**MASTER DEVELOPMENT DRAINAGE PLAN
AMENDMENT
FOR
STERLING RANCH**

**October 21, 2021
Project No. 25188.04**

Engineering Review

**EPC Planning & Community
Development Department**

PROPOSED DRAINAGE MAP
SAND CREEK MDDP AMENDMENT
JOB NO. 25188.04
08/17/21
SHEET 1 OF 1

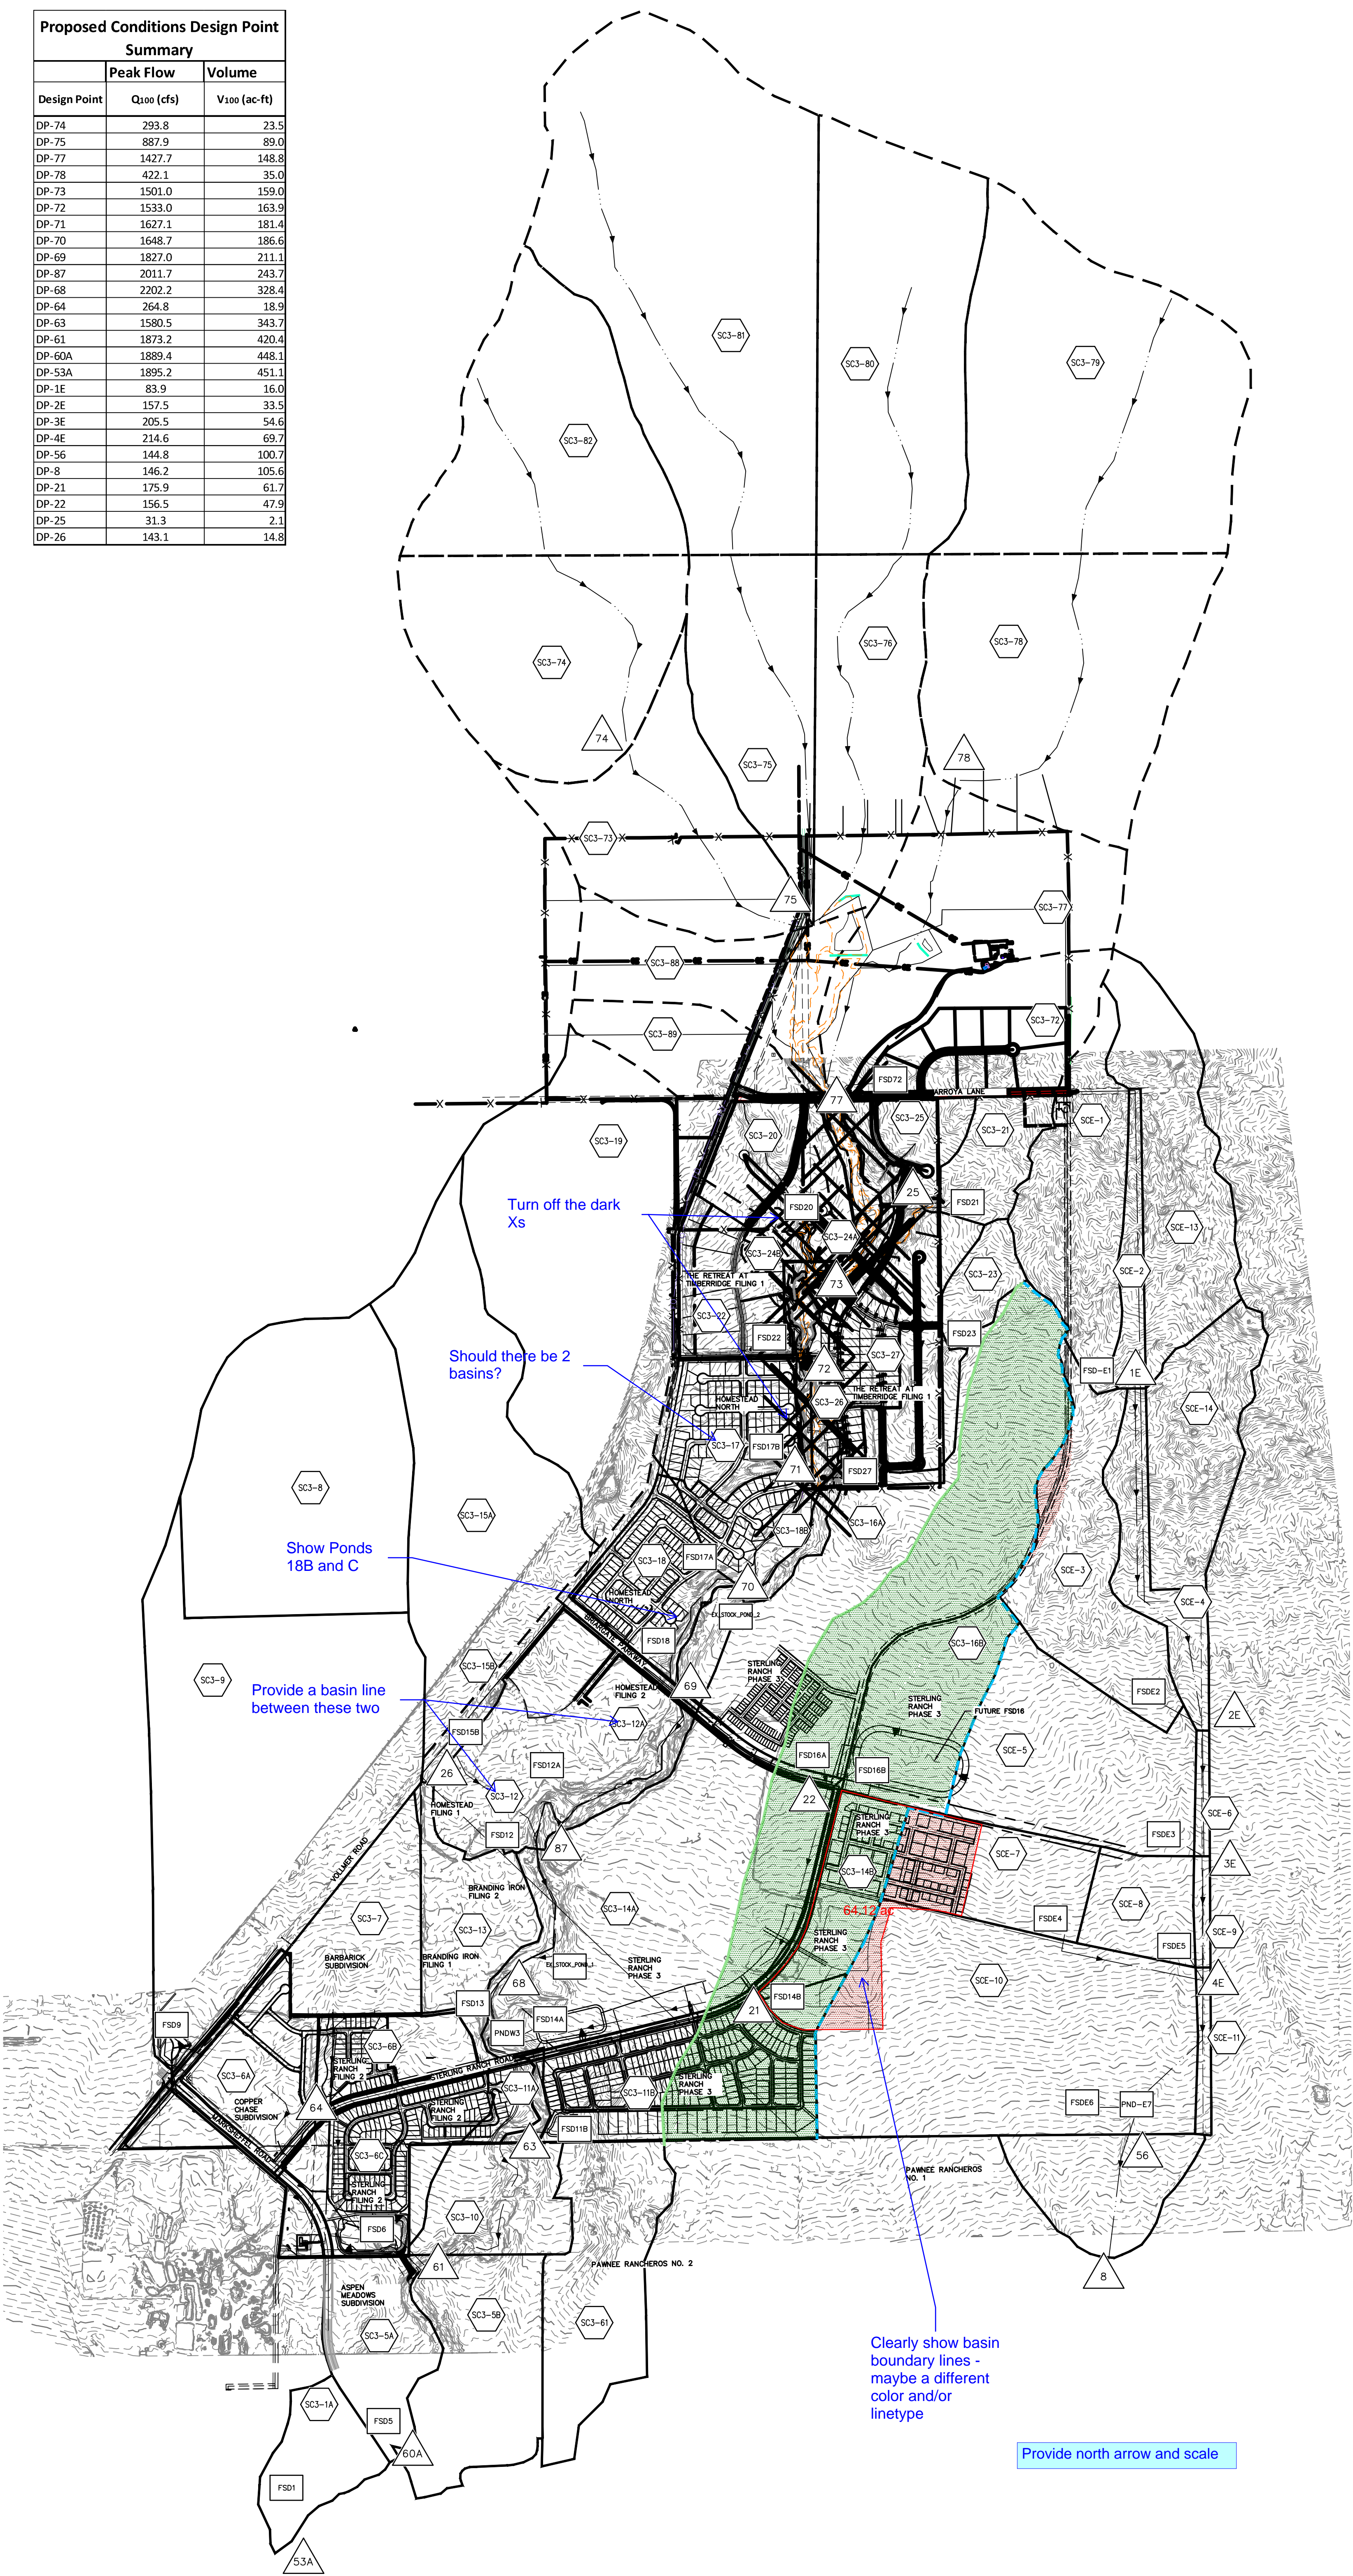
show A and B basins on the drainage plan
